RESPONSE TO REQUEST FOR ADDITIONAL INFORMATION

APR1400 Design Certification

Docket No. 52-046

RAI No.: 7-7855
SRP Section: 12.02 – Radiation Sources
Application Section: 12.2, 12.3, and 9.1.4
Date of RAI Issued: 05/14/2015

<Figure 1> Spent Fuel Assembly Dose Rate vs. Axial Distance in Refueling Pool

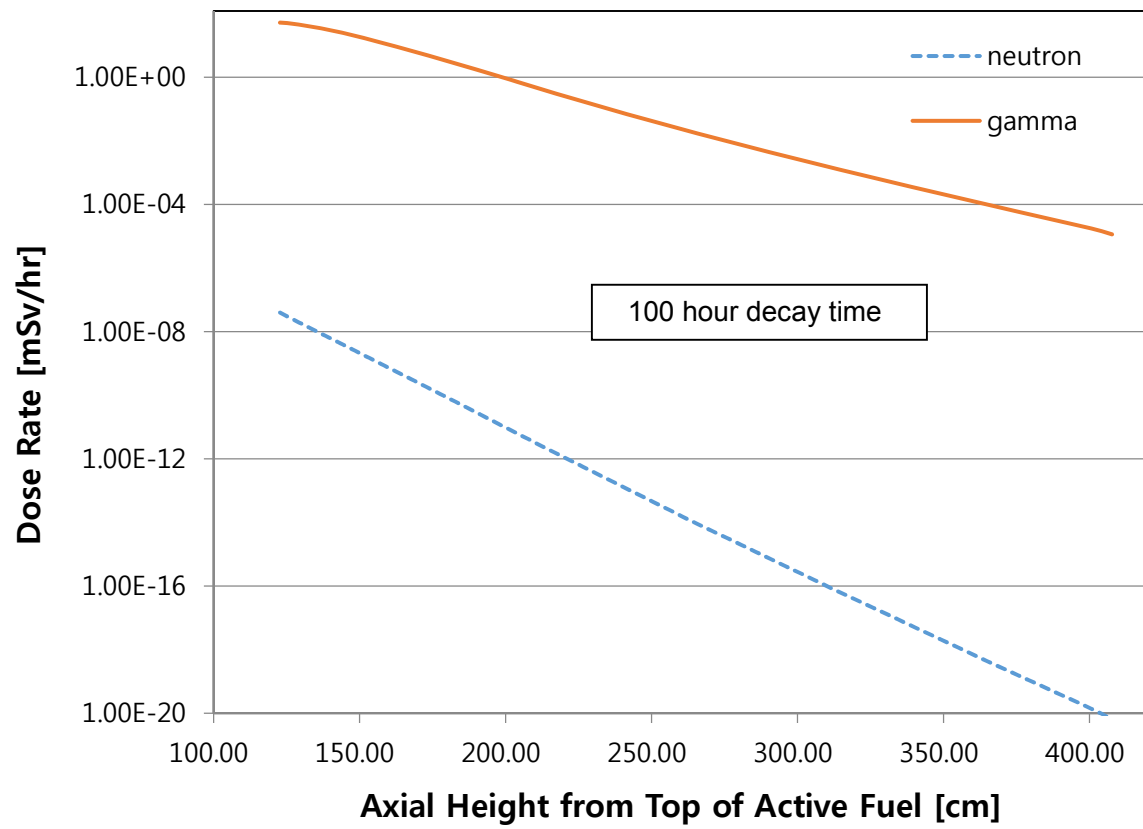
4. FSAR Figures 12.2-1 and 12.2-2 provide graphs of the dose rate from spent fuel vs. the axial and radial distances from a fuel assembly, however, the text of the application does not provide any information related to these graphs. Please update the text of FSAR Chapter 12 to provide information describing these figures. Include in the discussion how this information was developed, if this information is based on the maximum fuel assembly or an average assembly, if the dose rate includes the contributions from neutrons, and how it can be used to determine the maximum dose rate to an operator on the refueling platform during refueling operations and the maximum required shielding during transfer through the fuel transfer tube.

- a. While FSAR Section 12.3.2.3 describes how shielding around the fuel transfer tube was determined, the application does not discuss the source term used to determine doses from a raised fuel assembly to an operator on the refueling machine and spent fuel handling machine, or the minimum amount of water shielding required over a raised fuel assembly. Please update the FSAR to discuss this source term and to provide a discussion of the maximum dose rate to an operator on the refueling platform including the minimum amount of water above a raised fuel assembly in order to maintain dose rates on the refueling platform within the ANSI/ANS 57.1-1992 criteria, or provide an

The Chapter 12 radiation zone figures indicate a dose rate above the spent fuel pool of less than 2.5 mrem/hour (0.025 mSv/hour), which is acceptable from for compliance with ANSI/ANS 57.1-1992, however, there are no radiation zone maps for refueling inside containment and the normal operation radiation zone maps provide a zone above the reactor cavity of less than 500 rem/hour (5000 mSv/hr). Please correct this apparent discrepancy. If the dose rate to an operator above the spent fuel pool and refueling cavity during fuel movement will be maintained less than 2.5 mrem/hour please ensure that it is clearly indicated in the FSAR, that the mechanical stops will prevent fuel from moving to a height that would result in dose rates of greater than 2.5 mrem/hour to an operator. If doses to an operator will not be maintained to less than 2.5 mrem/hour, please justify an alternative approach.

DCD Figure 12.2-1 shows the dose rates for the refueling machine operator during refueling operation according to the axial height from top of active fuel in the refueling pool. "Axial height from top of active fuel" is determined by the refueling machine hoisting limit (mechanical stop) of the fuel assembly during refueling operation.

DCD Figure 12.2-2 shows the dose rates according to the radial distance from edge of active fuel in the refueling pool.

The dose rate to an operator on the refueling platform is determined by the dose rate value corresponding to the axial height (or water depth) from top of active fuel to the refueling pool water level after 100 hour decay time as provided in the DCD Figure 12.2-1.

DCD Sections 12.2.1.1.4 and 12.2.5 will be revised to provide the information describing Figures 12.2-1 and 12.2-2. Refer to Attachment 1 for the DCD markups.

The dose rate to an operator on the refueling platform is determined by the dose rate value corresponding to the axial distance (or water depth) from top of active fuel to the refueling pool water level after 100 hour decay, as provided in DCD Figure 12.2-1. Since mechanical stops in both the refueling machine and spent fuel handling machine restrict withdrawal of the spent fuel assemblies above the minimum safe water cover depth of 274.32 cm (9 ft) from top of active fuel, an operator on the refueling platform will not be exposed to the radiation dose limits (0.025 mSv/hr) in the work area when the shielding of the fuel handling equipment is taken into account.
